Informal Document No. GRRF-59-19  
(59th GRRF, 30 January - 3 February 2006  
agenda item 5.2.)

Working Party on Brakes and Running Gear (GRRF)  
(Fifty-ninth session, 30 January - 3 February 2006,  
agenda item \*\*)

PROPOSAL FOR DRAFT AMENDMENTS TO REGULATION No. 117

Transmitted on behalf of the GRRF ad-hoc tyre wet grip group

**Annex 2.**

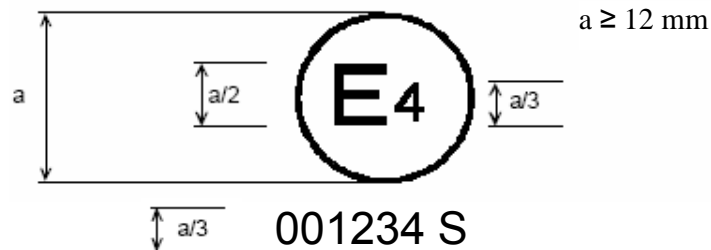
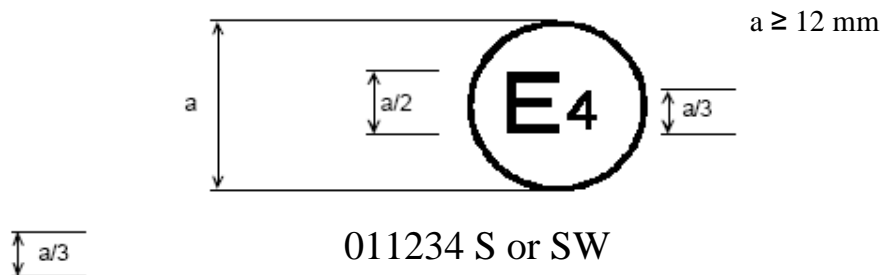
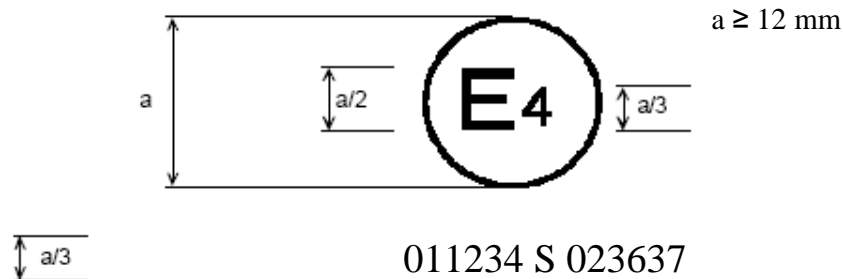
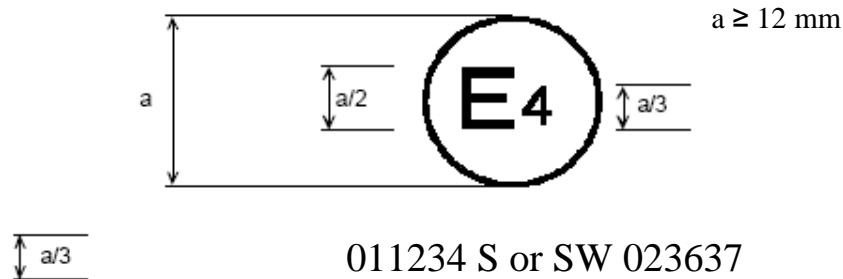
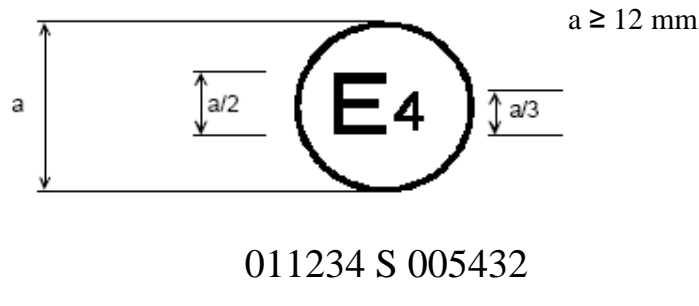
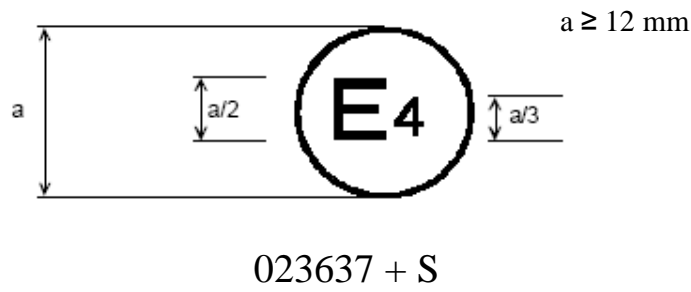
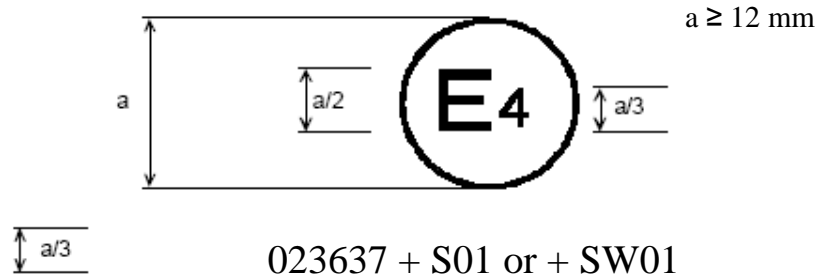
Replace Annex 2 with the following,

The proposed Annex 2 details a new approach for the approval marking of tyres.
